Access Compliance Report

Public Rights-of-Way

(Curb Ramps)

Intersection ID: 48949	Main Street: OLD_STONE_CROSSING_DR	Cross Street: DAVID_JENNINGS_AV	Location: SE
ADA ID: BA86AA3E565D	Ramp Type: Perp	Initial Pass/Fail: Pass	Overall Compliance: No
		Severity Score: 5.25	
Codes/Mitigation Info/Possible Solution		Field Measurements/Component Compliance

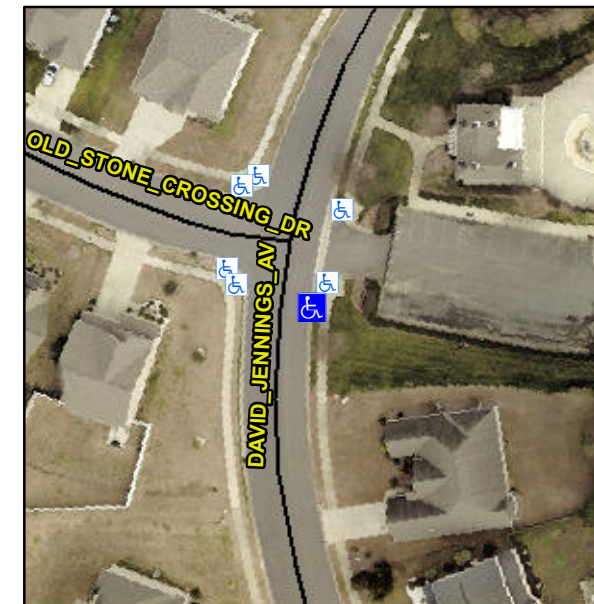
**Not Found, R304.5.3, R305.2,
R304.5.4**

Compliance	Description	Data	Compliance	Description	Data
N/A	Ramp Length (in)	47.0	Yes	Ramp Slope (%)	5.3
Yes	Ramp Width (in)	48.0	No	Ramp XSlope (%)	3.0
N/A	Flare Type LT	Sloped	N/A	Flare Type RT	N/A
N/A	Flare Slope LT (%)	1.6	N/A	Flare Slope RT (%)	4.6
N/A	Flare Traversable LT?	Yes	N/A	Flare Traversable RT?	No
Yes	Landing Length (in)	59.5	Yes	DWS Provided?	Yes
Yes	Landing Width (in)	48.0	Yes	DWS Contrast?	Yes
Yes	Landing Slope (%)	2.0	Yes	DWS Length (in)	24.5
No	Landing X Slope (%)	2.3	Yes	DWS Full Width?	Yes
N/A	Landing Curb? (Y/N)	No	No	DWS Offset (in)	5.0
N/A	Shared Landing?	No			
Yes	Gutter Ponding?	No	No	Gutter Slope (%)	12.5
Yes	Gutter Lip Ht (in)	0.0	Yes	Gutter X Slope (%)	1.8
N/A	Painted X Walk1?	No	N/A	Painted X Walk2?	N/A
	X Walk 1 Direction	To W		X Walk 2 Direction	N/A
N/A	X Walk 1 Width (in)	N/A	N/A	X Walk 2 Width (in)	N/A
	X Walk 1 Slope (%)	1.9		X Walk 2 Slope (%)	N/A
	X Walk 1 X Slope (%)	1.8		X Walk 2 X Slope (%)	N/A

N/A	Ramp inside XWalk1?	N/A	N/A	Ramp inside XWalk2?	N/A
	Road Slope (%)	N/A	N/A	Clear Space?	Yes
	Road X Slope (%)	N/A	N/A	Clear Space to XWalk (in)	N/A
Yes	Any Obstructions?	No	Yes	Storm Grate/Utility Hazard?	No
	Obstruction Type			Storm Grate/Utility Type	
		N/A			N/A
			Yes	Surface Condition? (G/P)	Good

**Remove & Replace Entire Ramp.
Remove & Replace Gutter.**
